HPCL/GM-SKHPP/AFL/2020 2766-67 Dated: 24/07/2020

Sub: Diversion of 07.3722 ha of Additional Forest land in favour of Himachal Pradesh Power Corporation Ltd. for construction of Shongtong Karchham HEP, 450 (MW).

In reference to the subject cited above, point wise reply/ clarification to the observations raised vide CF, Rampur letter 7601 endorsed vide above referred letter is as under:

ALTERNATIVES CONSIDERED AVOIDING / MINIMISING THE USE OF FOREST LAND FOR THE CONSTRUCTION OF SHONGTONG-KARCHHAM HYDRO ELECTRIC PROJECT (450MW).

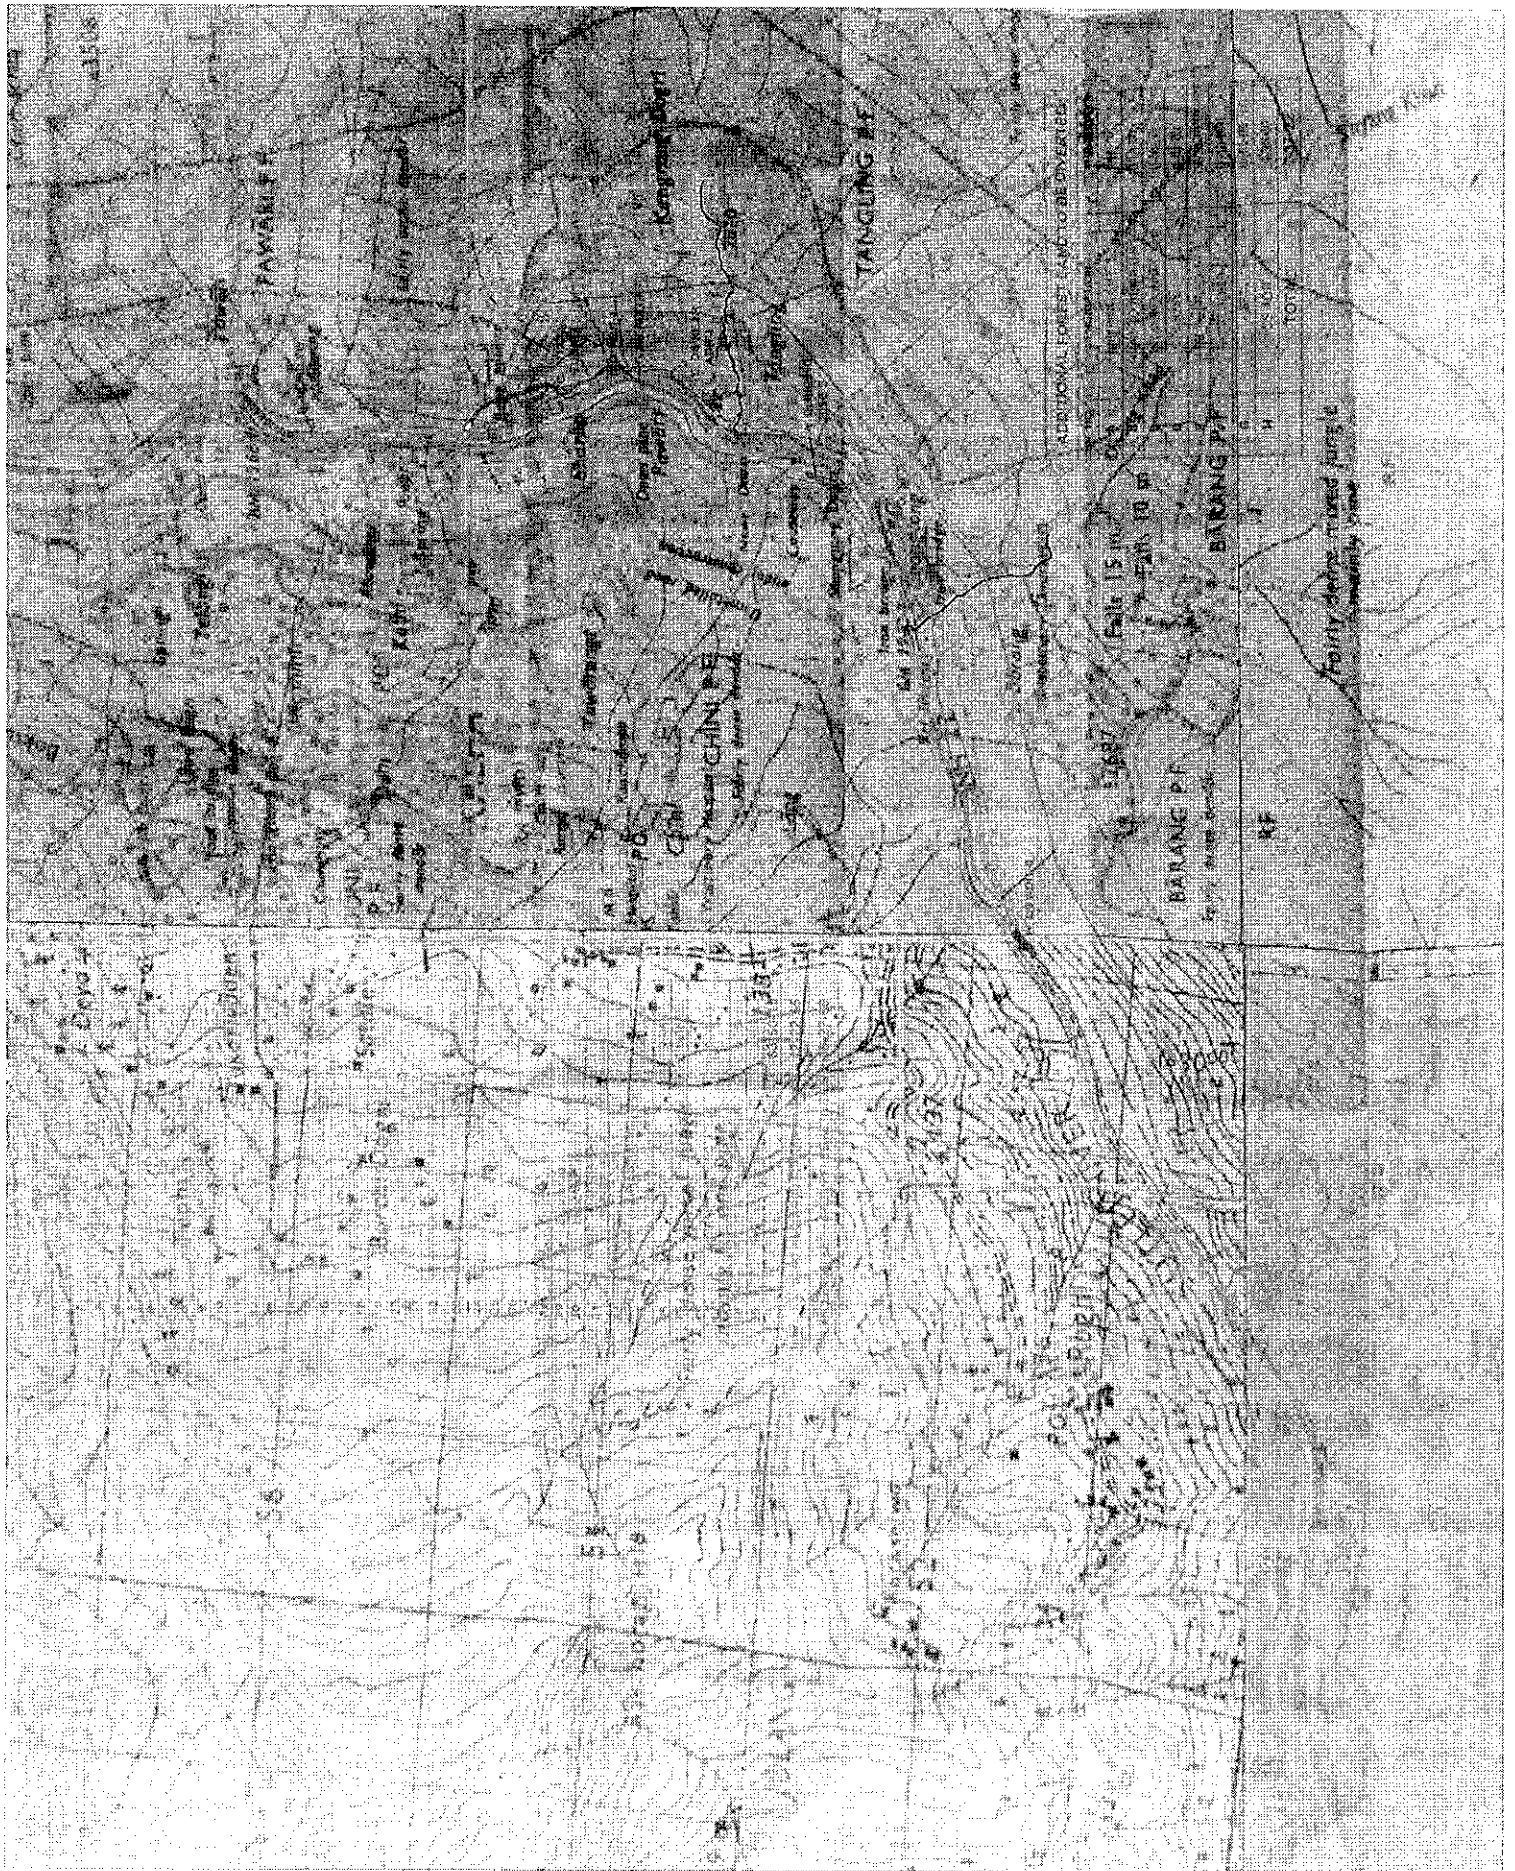
The team comprising of Divisional Forest Officer, Kinnaur Forest Division, Sub-Division Kalpa and the Authorized Signatory of HPPCL, have jointly inspected the proposed site for development/ construction of Shongtong - Karchham Hydro Electric Project (450MW) and examined three alternatives with a view to avoid/minimize the use of forest land and the trees to be felled:-

Present proposal of additional forest land to be diverted is best suitable and sync with the already diverted forest land for intakes Sedimentation Chamber, HRT and power house located on the left bank of the river. left bank was found more suitable as the components of the project intercept less forest land and it also provide good geological conditions to construct the various components of the project, as compare to the right bank and no other suitable area was available, where use of forest land could be avoided/ minimized. In the present proposal, due to change in capacity / Capacity enhancement from 402 Mw to 450 MW and restriction imposed by the Army authorities for the construction, re-

alignment of some components were made due to which this necessity of add. Forest land was arise to undertake the construction works for the successful completion of project for the interest of State as well as nation . Keeping in view the minimum requirement of add. forest land and presence of minimum vegetation in the Proposed addl. Forest land & area required is also low and is mostly rocky/barren. While there is small destruction of green vegetation, therefore this location is suitable for the construction of components of t project

**PROPOSED AREA FOR SILT FLUSHING TUNNEL, PORTAL, WORKING AREA AND
APPROACH ROAD (KHASRA NO. $1 \frac{838}{1}$ & $1 \frac{840}{1}$) MEASURING 0-85-95 HECTARE**

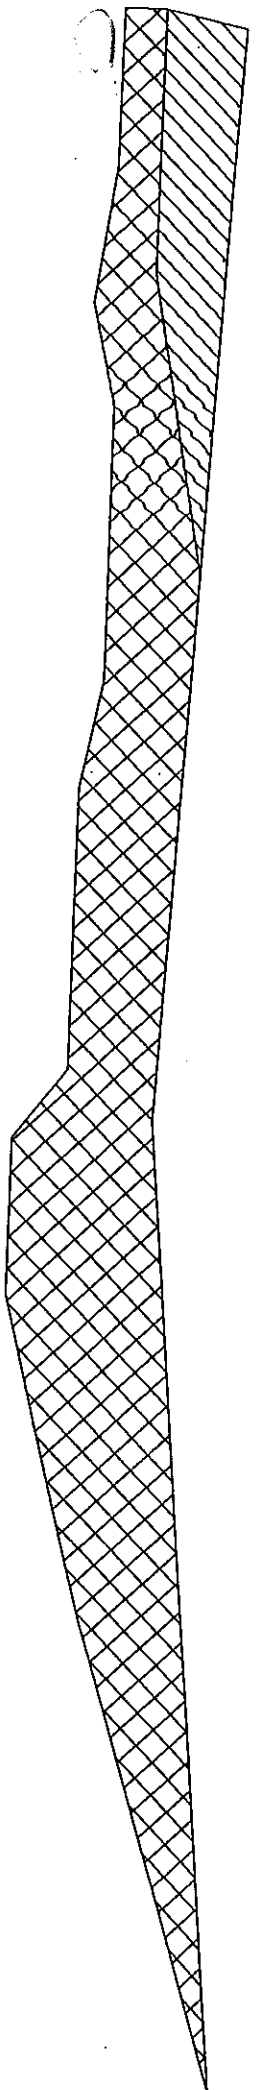
- (vii) The land measuring 0.7980 ha is diverted only for underground portion of SFT. Now the land measuring 0.1573 ha in Kh. no. 1/1, 0.3586 ha in Kh no. 838/1, 0.0200 ha, and 0.3436 ha, in Khasra no. 840/1 is to be diverted for outlet portion of SFT and approach. Already diverted land measuring 0.7980 ha, is not to be surrendered being used for Project Construction.
